SAN FRANCISCO PLANNING DEPARTMENT

Discretionary Review Staff Initiated Full Analysis HEARING DATE MARCH 3, 2011

Date: February 24, 2011
Case No.: 2011.0100D
Project Address: 422 Day Street
Permit Application: 2010.09.14.0807
Zoning: RH-1 (Residential House, One-Family)
40-X Height and Bulk District
Block/Lot: 6630/009
Project Sponsor: Mark Macy, Macy Architecture
315 Linden Street
San Francisco, CA 94102
Staff Contact: Michael Smith – (415) 558-6322
michael.e.smith@sfgov.org
Recommendation: **Take Discretionary Review and approve with modifications**

1 THIRD FLOOR PLAN
1/4" = 1'-0"

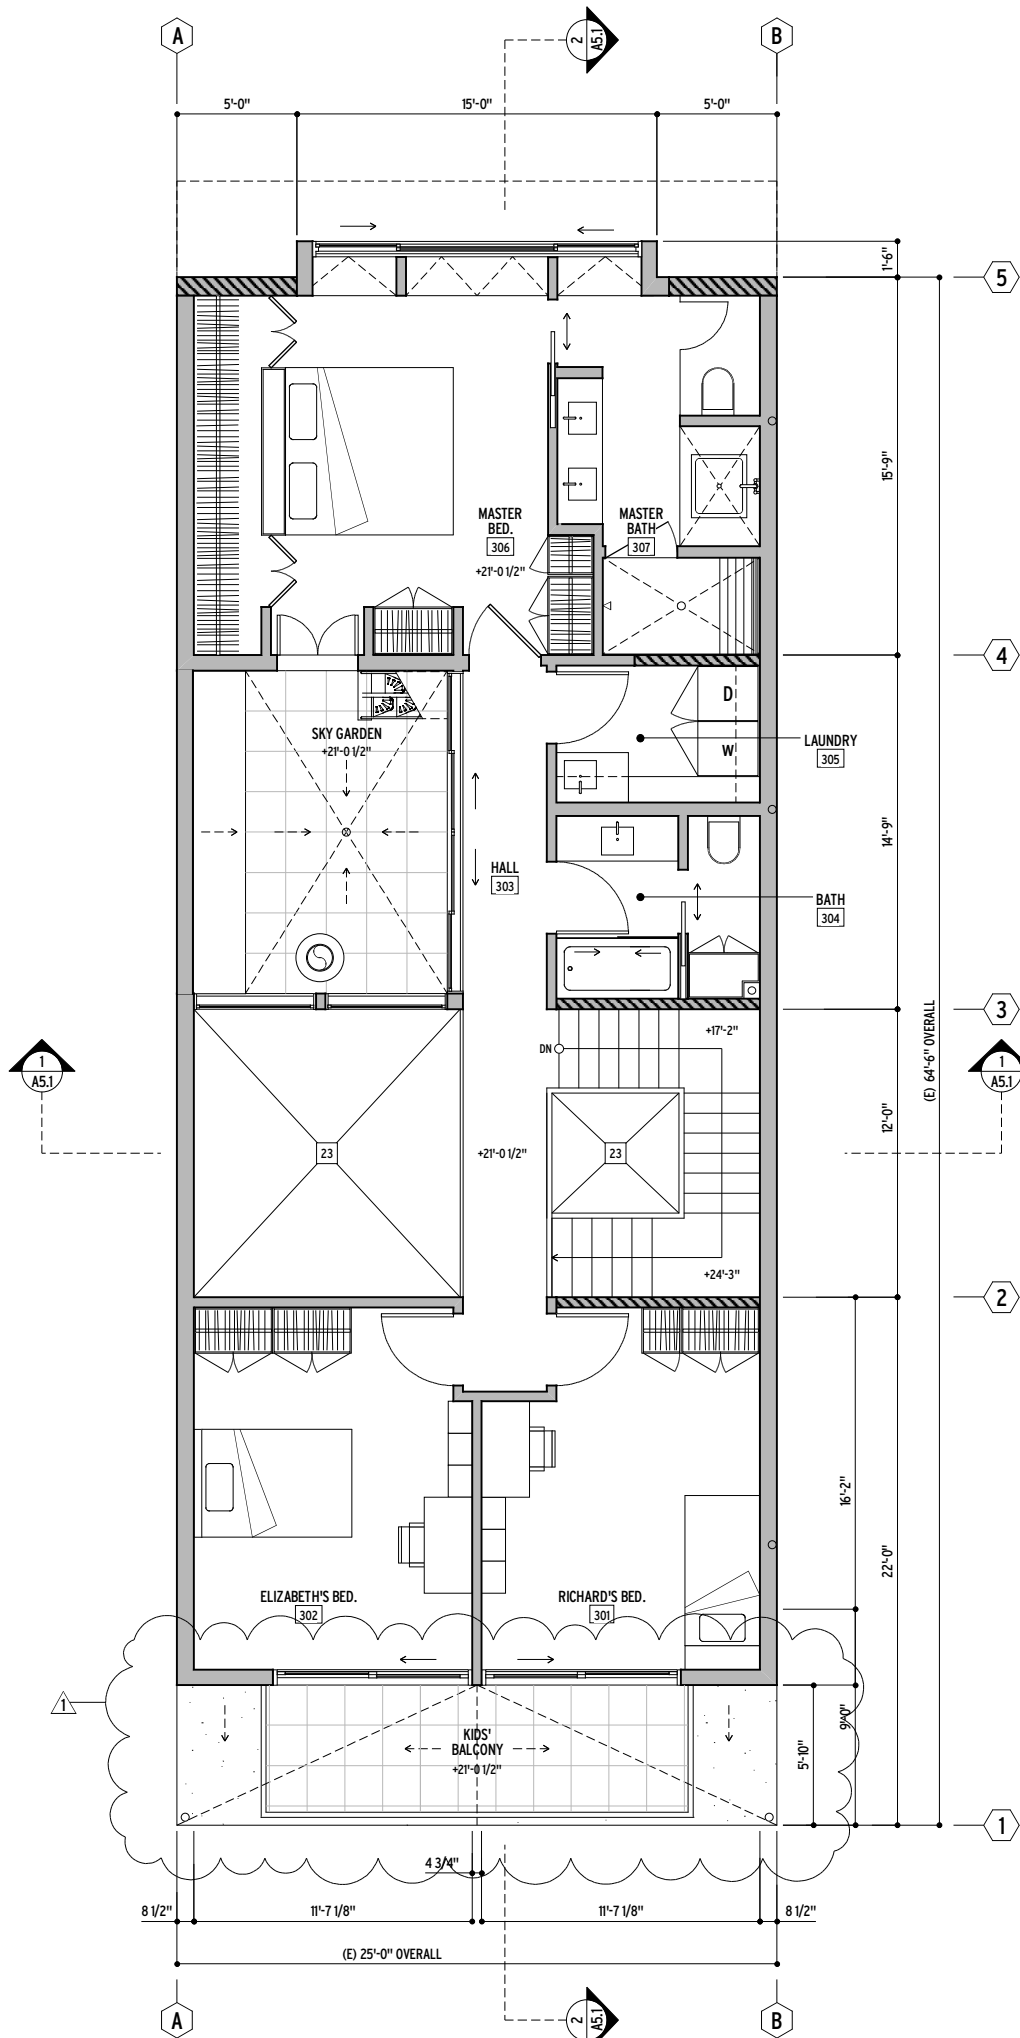
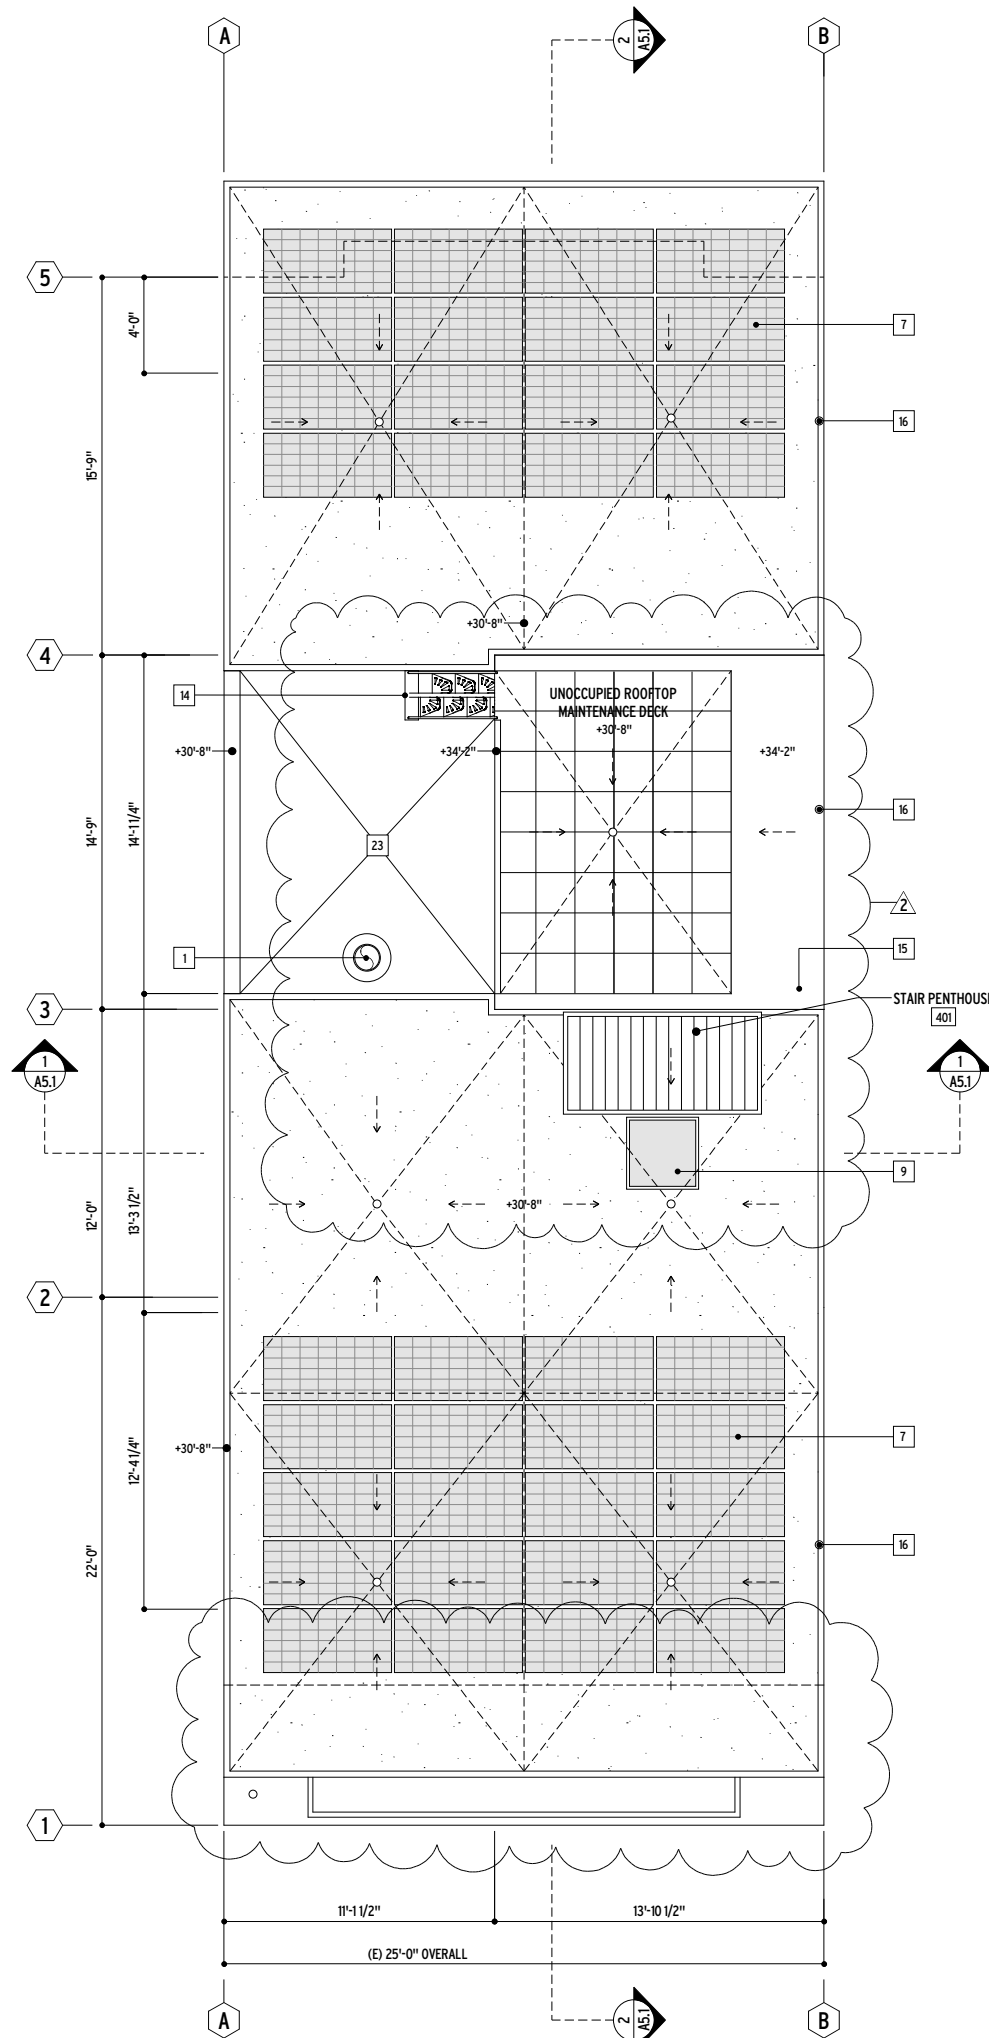
A 15-foot front setback is needed to respect the existing building scale at the street. A third floor rear setback is also needed to respect the mid-block and respond to the shorter building to the east.

- A 15-foot front setback at the third floor would protect the existing building scale at the street.
- A rear setback at the third floor would soften the added height of the building as it frames the mid-block open space and reduce adverse light impacts on the adjacent building to the east.

- a. **Building Scale (pages 24-25).** The proposed building is one-story taller than the adjacent buildings and therefore appears incompatible with the neighborhood scale. To make the building more compatible with the scale of the neighborhood the Department recommends, setting back the third floor 15-feet from front building wall below (including the front eave overhang), and reduce the depth of the third floor to the average depth of the adjacent buildings.

The proposed 3rd story is set back 5'10" at the front and its roof is 4'-4" below the allowable height – making the project well within the envelope requirements of the Planning Code.

2 FRONT ELEVATION
 1/4" = 1'-0"

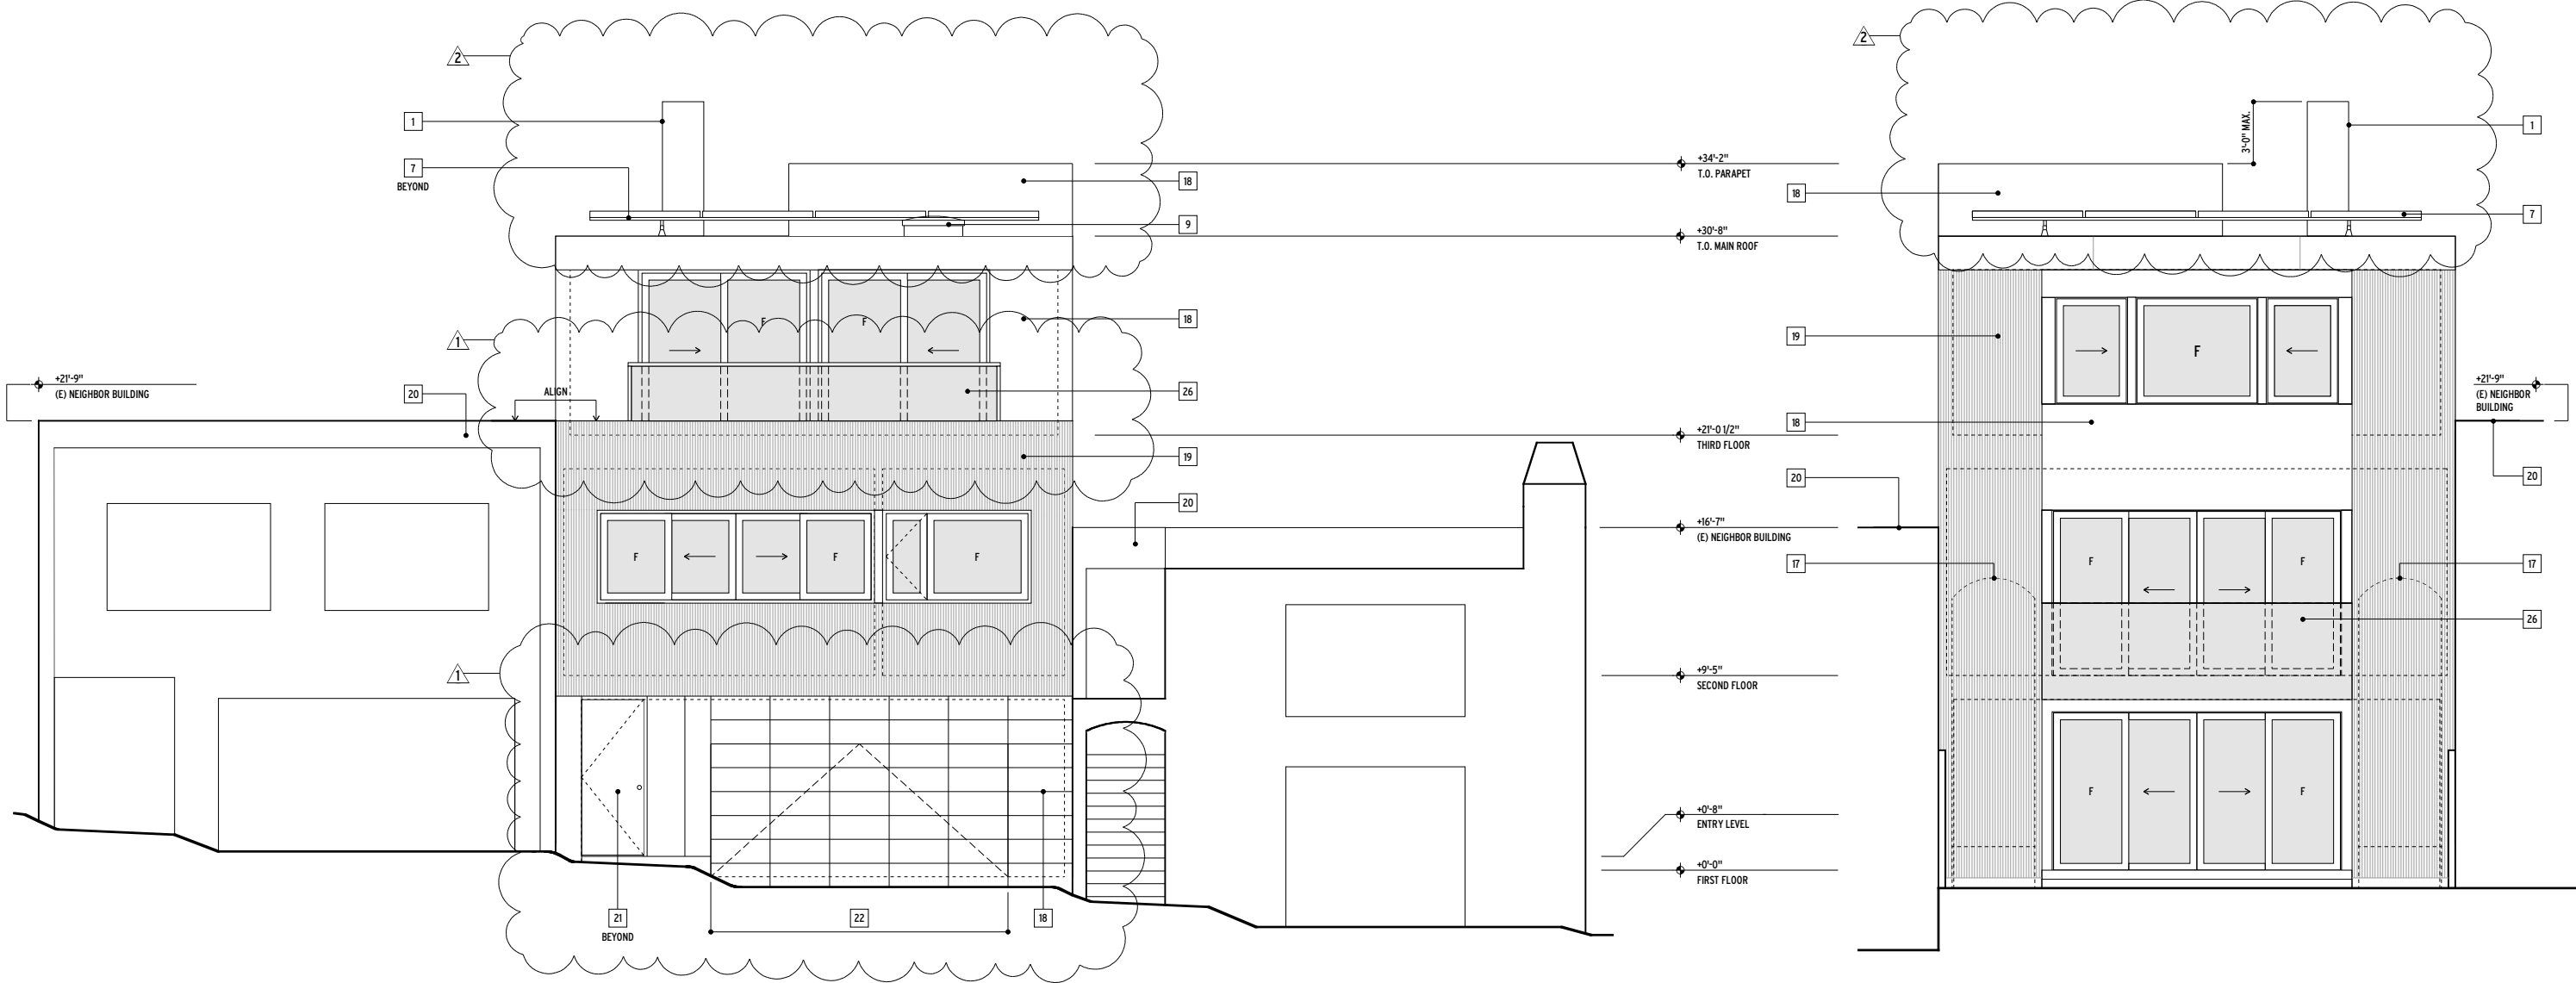
Comments: A majority of the buildings within the 400 block of Day Street are two-stories in height. Furthermore, the adjacent buildings to the east and west of the property are two-stories in height. Within this context a setback greater than 5'-10" is needed to protect the building scale at the street wall.
